## **CABINET MEMBER FOR ENVIRONMENT - 24 APRIL 2014**

### **HEADINGTON: LONDON ROAD SHARED USE FACILITY GREEN ROAD ROUNDABOUT TO GLADSTONE ROAD**

**Report by Deputy Director for Environment & Economy  
(Commercial)**

Drawing No. S-000634/CON/000/003		Revision 0

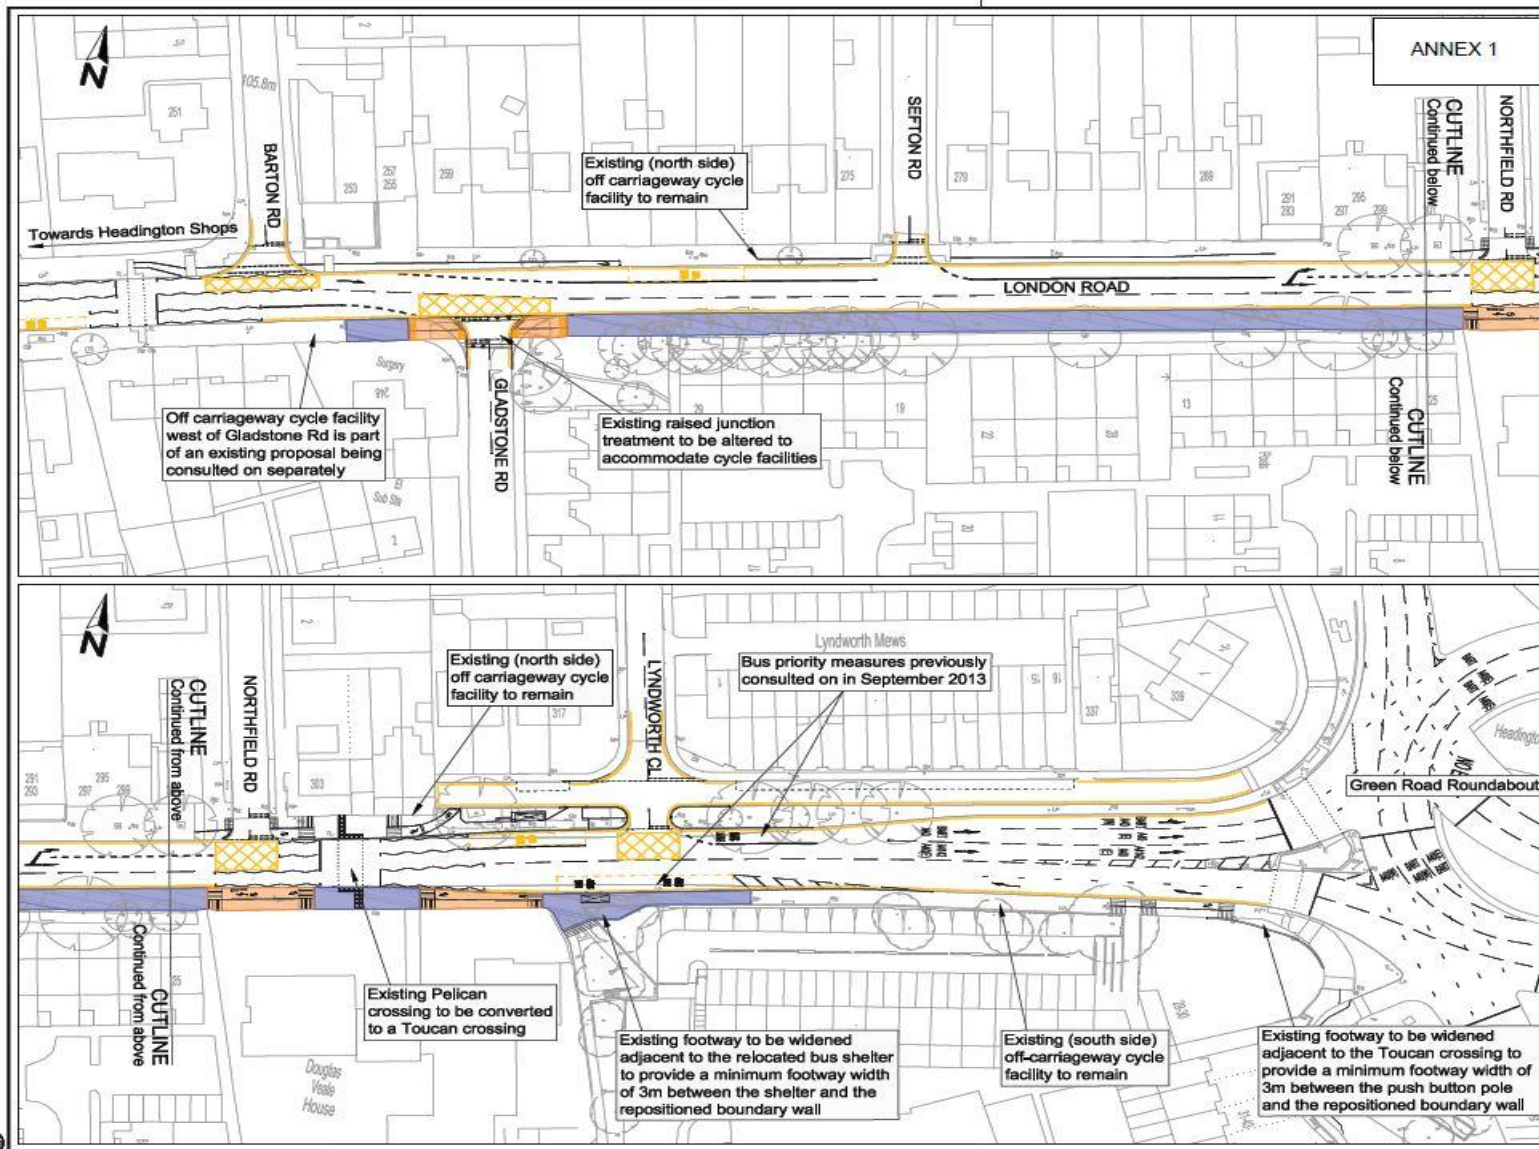
Respondent	Comments Received	Officer Comments
Councillor Roz Smith (Headington & Quarry Division)	Would prefer both elements of the proposed cycle facility to be implemented at the same time.	At the time of writing this report, it is understood that this will be the case and both elements of the proposed cycle facility will be constructed as part of the overall London Road Improvement Scheme due to commence in late Spring 2014.
City Councillor for Quarry & Risinghurst	Suggests the proposed facility should be clearly segregated.	Noted. The proposed layout will be amended to incorporate segregation of cyclists and pedestrians by means of an appropriate road marking.
Thames Valley Police	<p>Raised concerns relating to potential obstructions including the bus stop [opposite Lyndworth Close] and pedestrian crossing in the vicinity of Northfield Road, the location of lighting columns and overhanging trees.</p> <p>Commented that the mixture of segregated and un-segregated status may lead to misuse and conflict. The use of appropriate traffic signs and road markings will be essential.</p>	<p>It is proposed to locally widen the footway behind the bus shelter opposite Lyndworth Close in order to minimise the potential for pedestrian and cycle conflict. Existing street furniture including lighting columns and traffic signs and benches will be relocated to the back of the footway or removed if appropriate.</p> <p>The proposed layout will be amended to incorporate segregation of cyclists and pedestrians by means of an appropriate road marking.</p>

CTC, Right to Ride Representative	Commented that the scheme is an improvement on the original proposals consulted on last year as part of the improvement scheme consultation.	Noted.
Representative of The Guide Dogs for the Blind Association.	<p>Commented that the unsegregated status of the scheme is inconsistent with the proposals for the Gladstone Road to Wharton Road cycle scheme.</p> <p>Believes inconsistent use of tactile paving and intermittent use of segregation will lead to confusion for pedestrians.</p>	<p>Noted. The proposed layout will be amended to incorporate segregation of cyclists and pedestrians by means of an appropriate road marking.</p> <p>The layout of tactile paving will be reviewed in light of the proposed amendment to a segregated facility.</p>

Respondent	Comments Received	Officer Comments
<p>Representative of Oxonian CC and CTC Councillor</p>	<p>Commented that:</p> <ul style="list-style-type: none"> <li>• no mention of footway resurfacing has been made,</li> <li>• cycle priority is not provided across the Gladstone Road junction, which is not improved by the use of double yellow lines at the junction,</li> <li>• physical segregation rather than a road marking should be provided along the route; either a level difference between the cycle route and the pedestrian route, or the use of concrete kerb set into the footway,</li> </ul>	<p>Where kerb lines are to be altered, it is the intention to carry out full width footway resurfacing. In areas where kerb lines are to remain unaltered, areas of localised footway repairs will be made where required.</p> <p>Where cycle routes cross side road junctions the approach taken by OCC has not been to promote cycle or pedestrian priority over traffic using the junction. Cyclists are instructed to give way and observe before crossing the junction by the use of 'give way' markings. It is recognised that the prioritisation of cyclists over vehicles has been implemented elsewhere, notably as part of Old Shoreham Road cycling scheme in Brighton. Its use in Oxfordshire would have to be carefully considered.</p> <p>In light of the comments received during the consultation, It is now proposed to segregate pedestrians and cyclists by means of an appropriate road marking. Other forms of segregation (inlaid kerb or level difference) would be inconsistent with the current and proposed cycle facilities on London Road.</p>

<p>Member of the public who cycles daily between Headington and Wheatley</p>	<p>Supportive of the proposals but commented that the facility would be better if it was segregated.</p>	<p>Noted. The proposed layout will be amended to incorporate segregation of cyclists and pedestrians by means of an appropriate road marking.</p>
<p>Member of the public</p>	<p>Commented that scheme was long overdue but suggested the facility should be segregated.</p>	<p>Noted. The proposed layout will be amended to incorporate segregation of cyclists and pedestrians by means of an appropriate road marking.</p>
